Product Change Notification

PCN# PCN-218-2024-01

Product Part#	
EC61330_00MA

Description of change

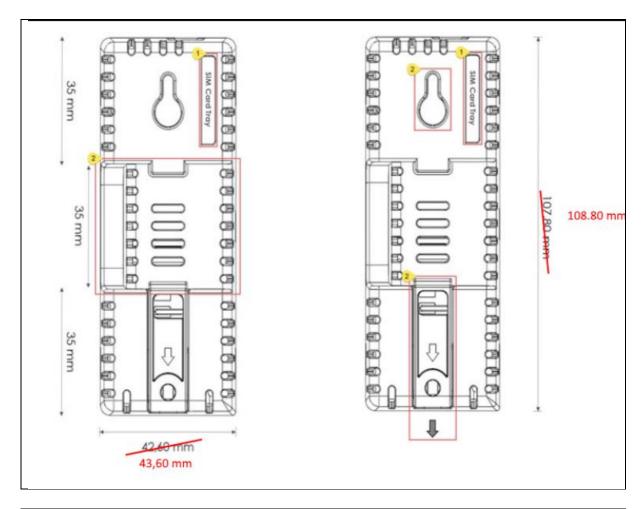
Key milestones		
From June 1st	Dimensions of the Cosy131 Ethernet devices will be changed in production: 1mm will be added in the current height and 1 mm on the current width. Depth will be unmodified. The change will be effective from the serial number starting with "2023-SSSS-22".	
	This change will be applied to Cosy WiFi and Cellular productions in August 2020.

Due to large volumes of Cosy 131 already produced, a new injection mold for Cosy 131 family was required.

Please see the drawing on second page. The new mold will lead to a more robust product and manufacturing process.
